PROJECT: DAVID STREET STATION
200 SOUTH DAVID STREET
CASPER, WYOMING 82601

ADDENDUM NUMBER TWO

This addendum number one dated Thursday September 8, 2016 is hereby appended to and became a part of the Contract Documents for the David Street Station, 200 South David Street, Casper, Wyoming. Drawings and specifications dated May 10th, 2016.

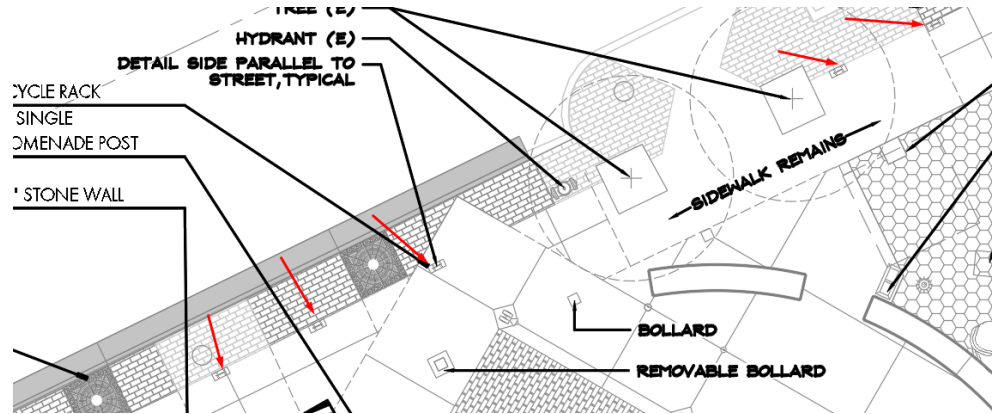
CLARIFY: Single bike racks five (5) are only along W. Yellowstone, locations denoted by red arrows in partial sketch below:

L-4a

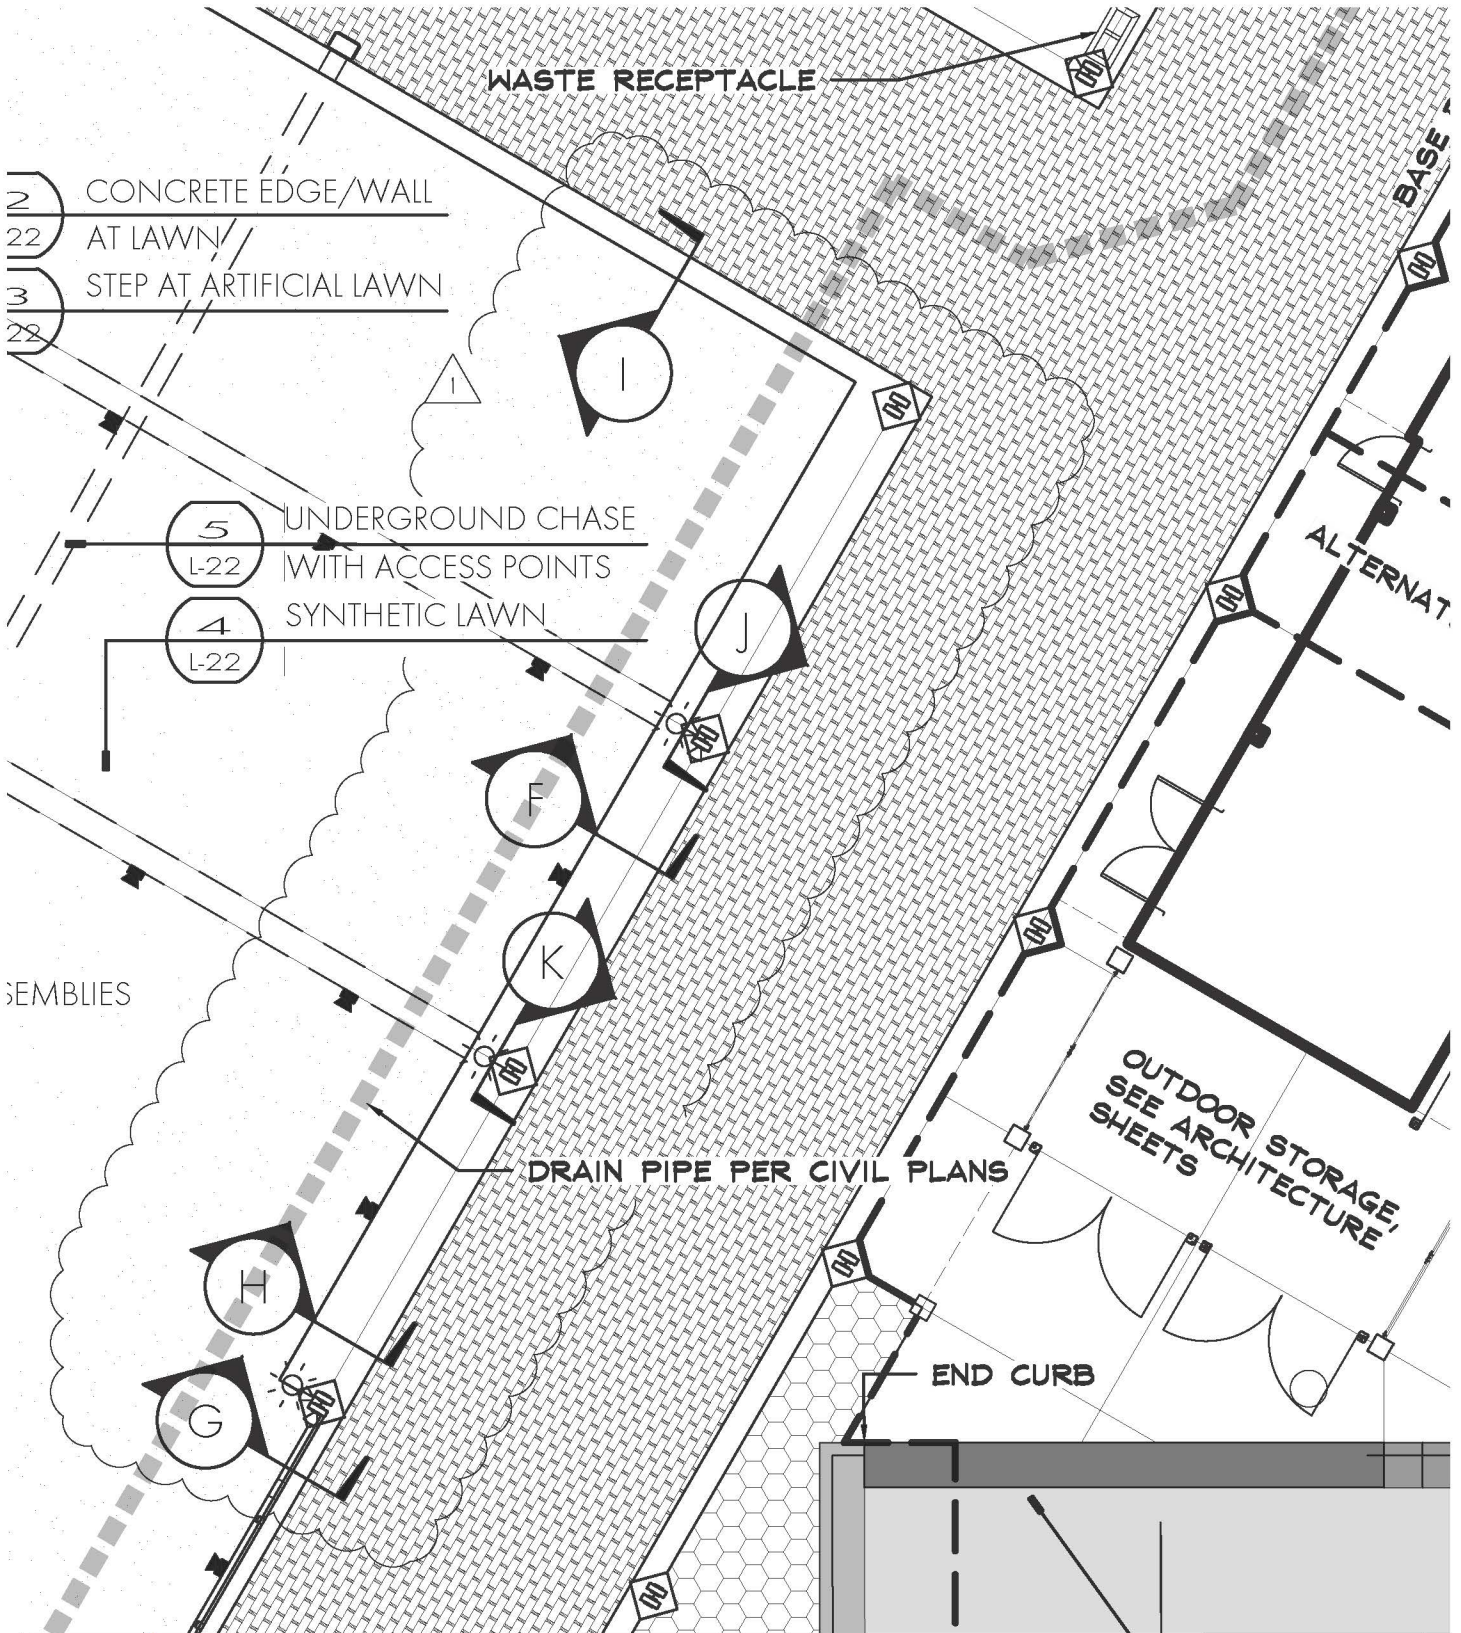
CHANGE: See revised Sheet L-4a attached for clarifications regarding the locations of the seat walls in Detail 2 “Concrete Edge and Wall at Lawn” on revised Sheet L-22a also attached. Section letter designations have been added to the detail and shown on the plan. In addition, “Section I – Concrete Band” is applicable wherever concrete exists between brick pavers and planters creating a concrete area the width of half of the diagonal of the 24” x 24” promenade post footing formed top.

www.tallgrasslandscapearchitecture.com 413 North 4th Street Custer, SD 57730 605.673.3167 TALLGRASS Landscape Architecture for the American West	Project:	David Street Station	Addenda #2
	Sheet Name:	Revised Layout Plan	
	By: MDF	Date: Sept. 8, 2016	L-6a

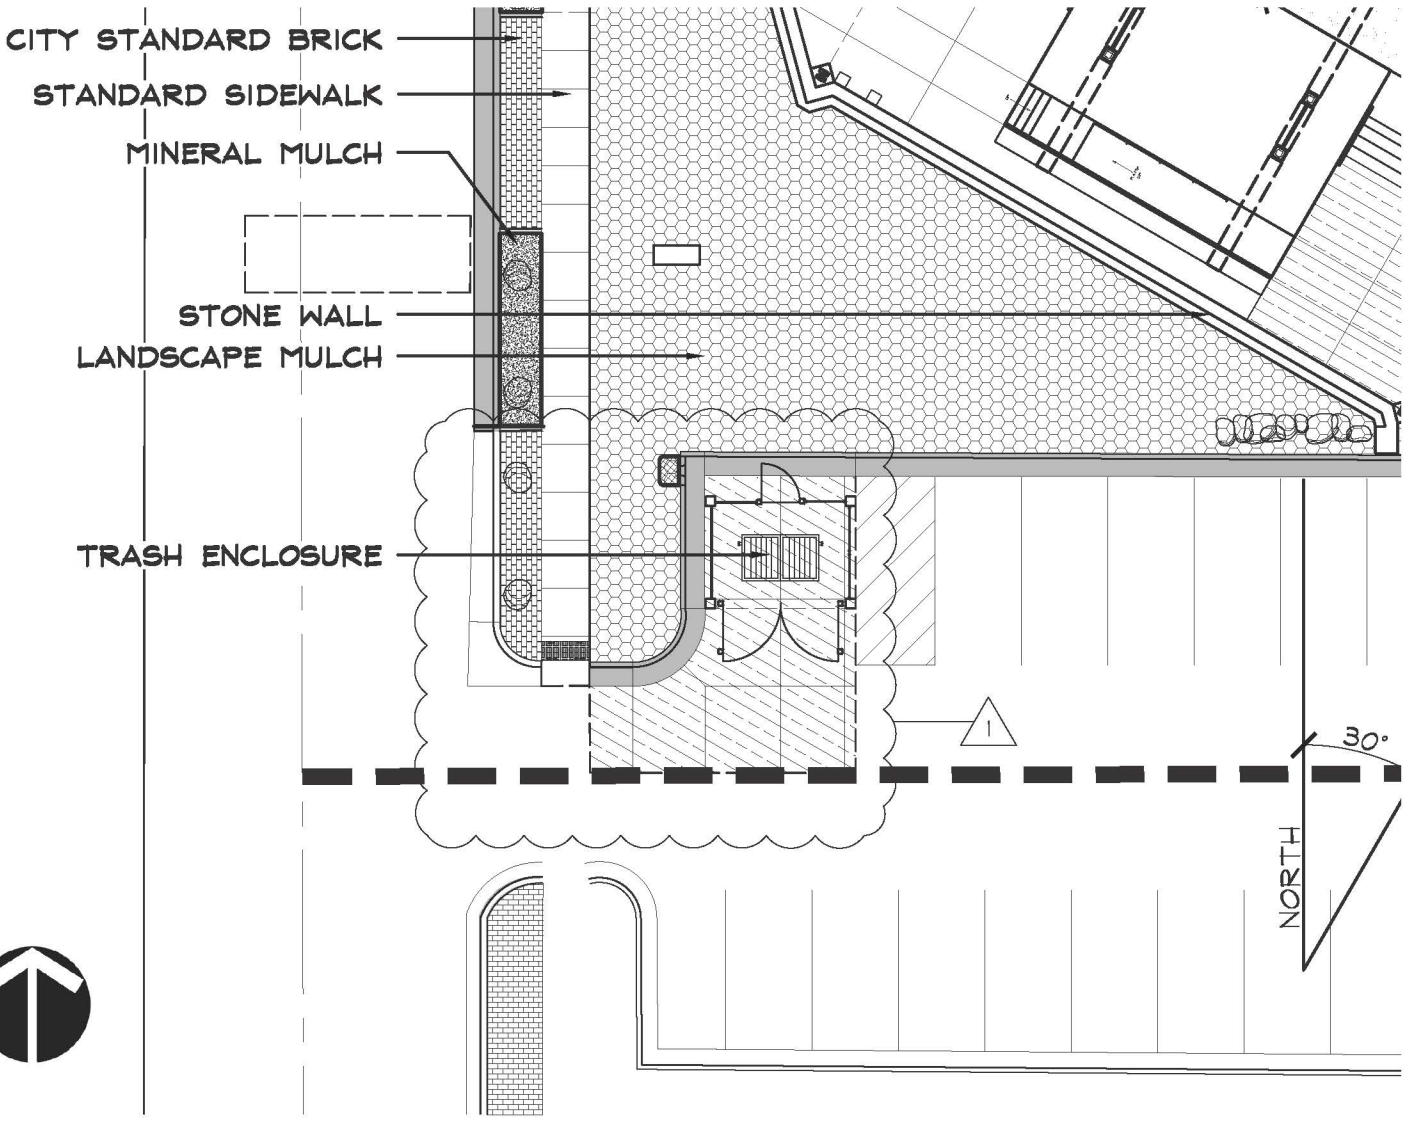
CLARIFY: See revised Sheet L-6a attached for area at trash enclosure that should be designated as Type 1B concrete, increasing the total Type 1B Base Bid area to approximately 1,385 SF (see General Note regarding provided quantities).

L-10a

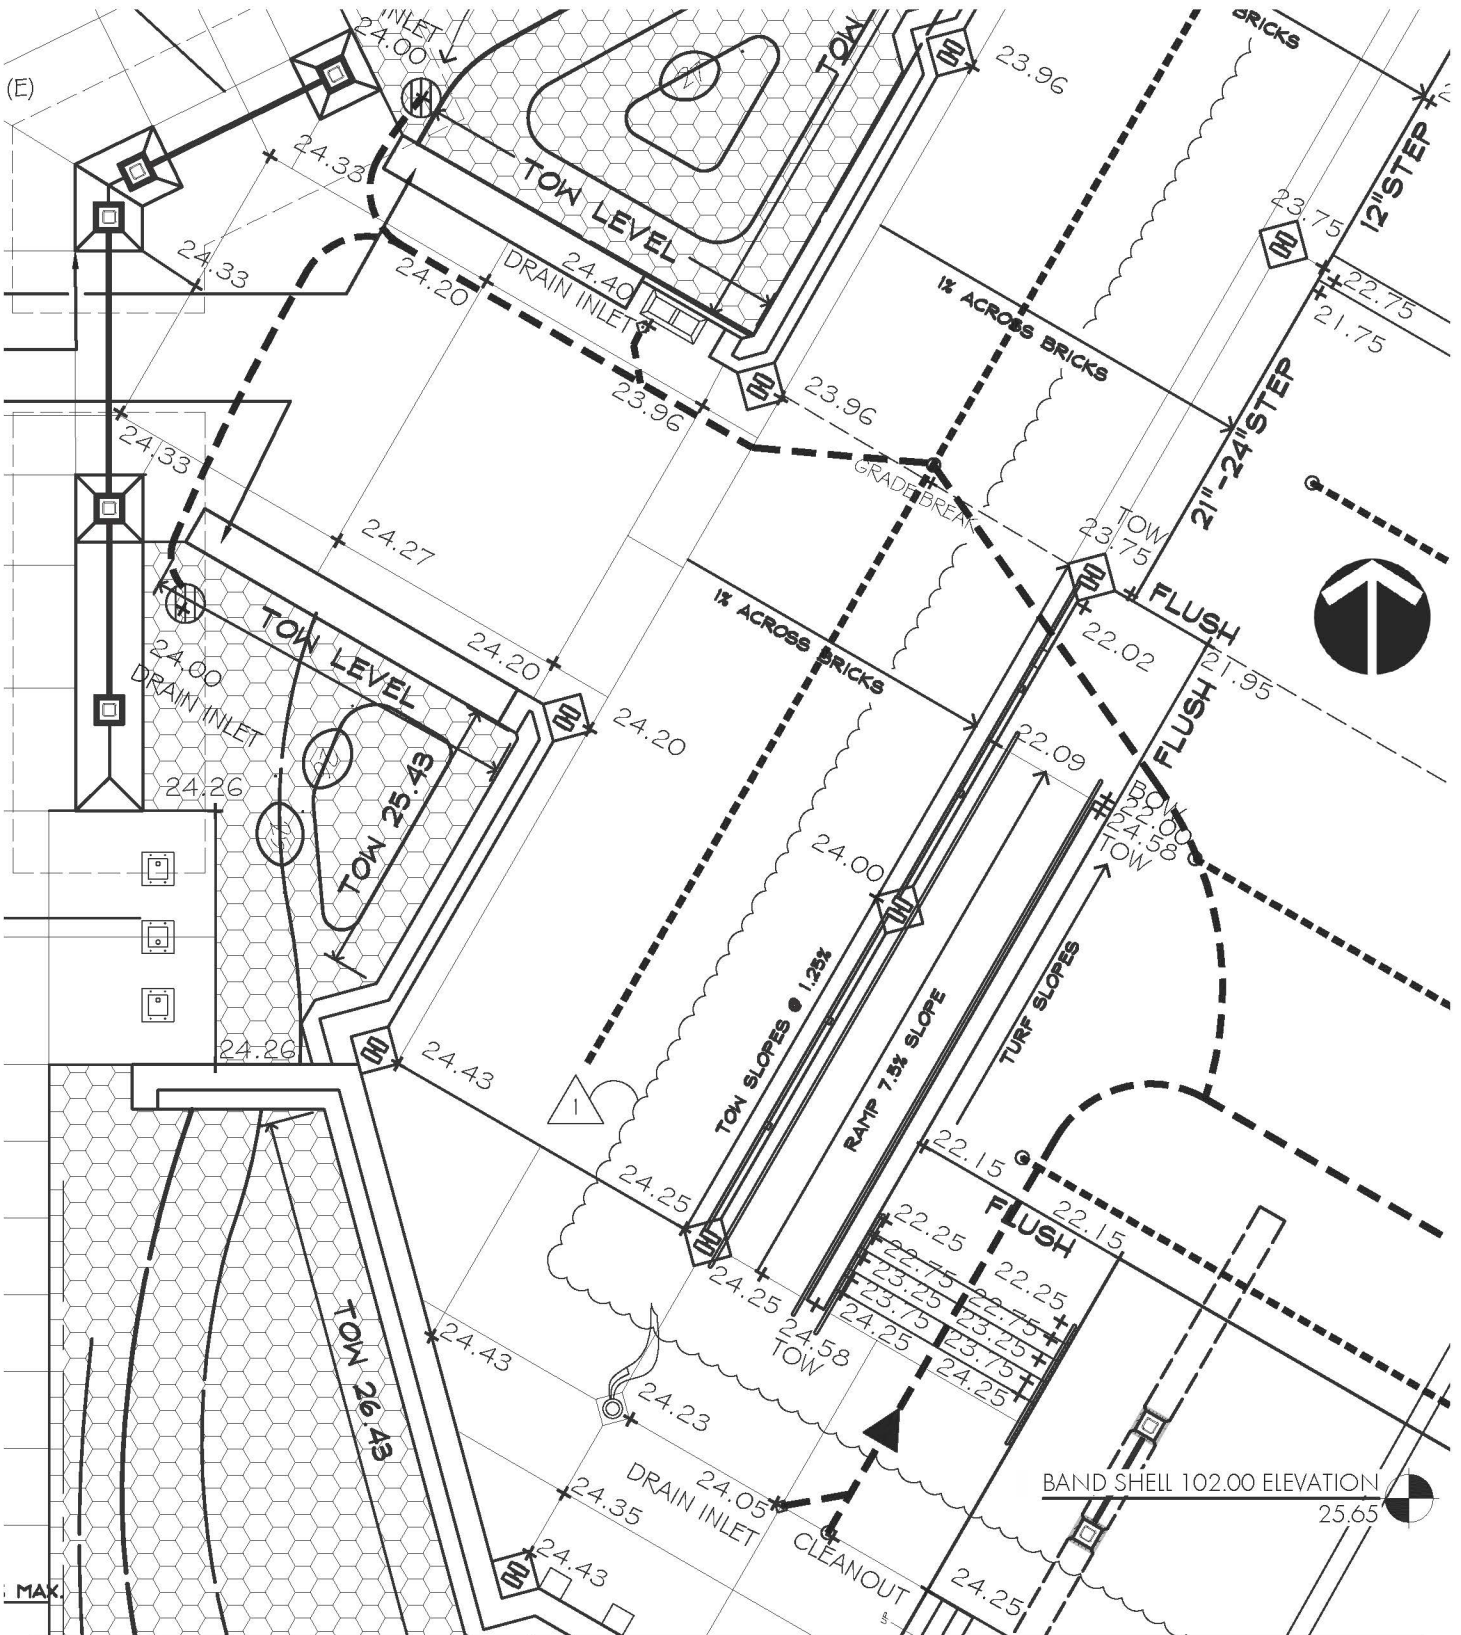
CHANGE: See revised Sheet L-10a attached for locations of type BL curb. Type P is indicated on plans as “Flush”

L-11a

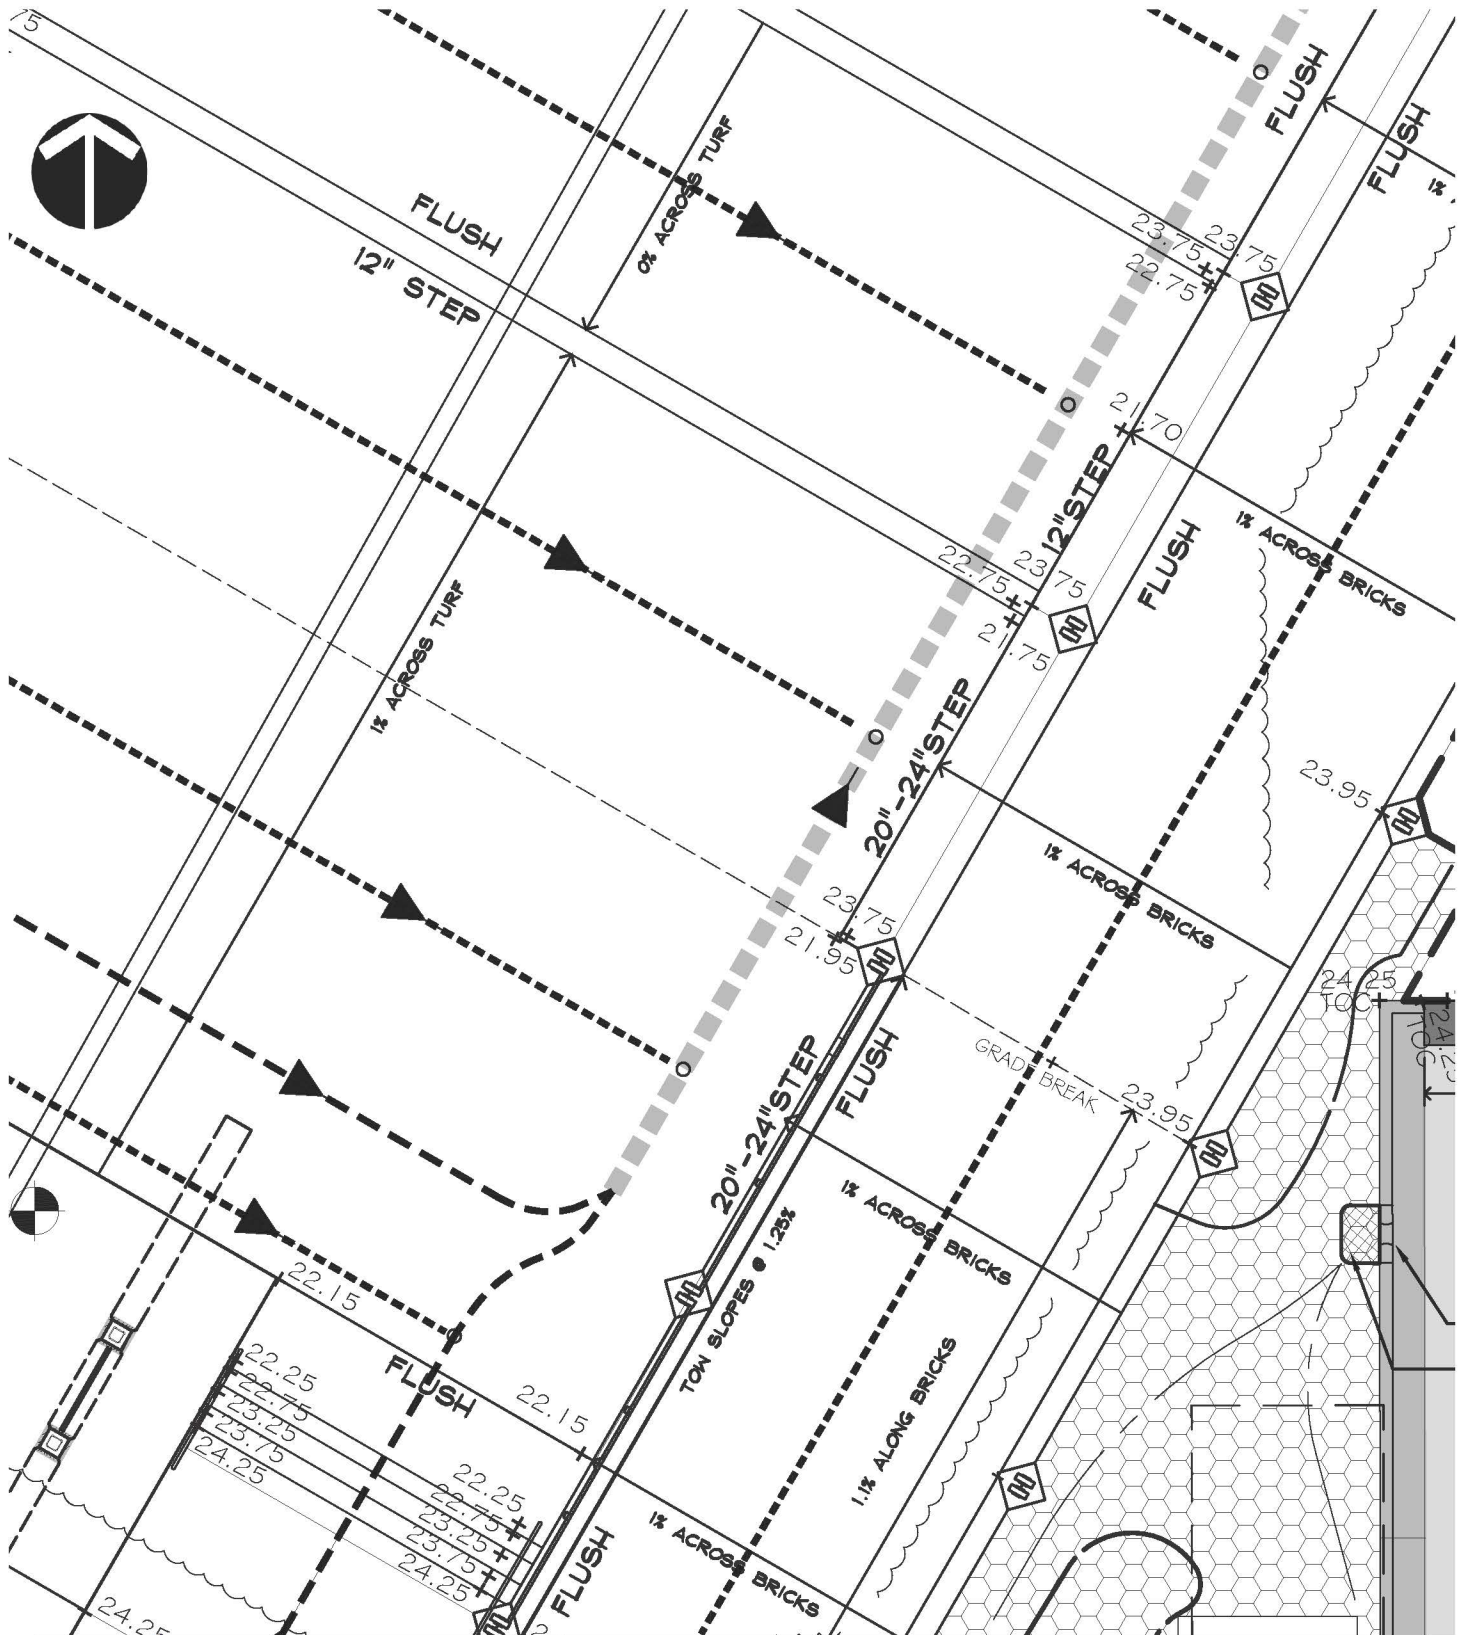
CHANGE: See revised sheet L-11a and b attached for additional spot grades around the stage area.

L-17a

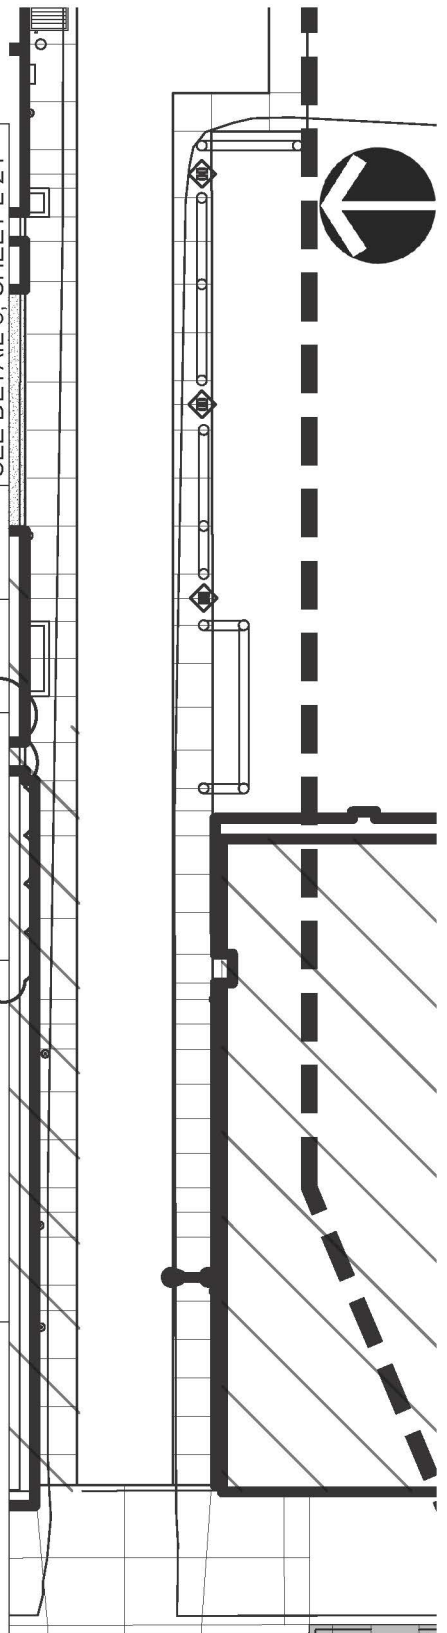
CHANGE: See revised sign size and notes on L-17a attached for size and type of material of the larger signs.
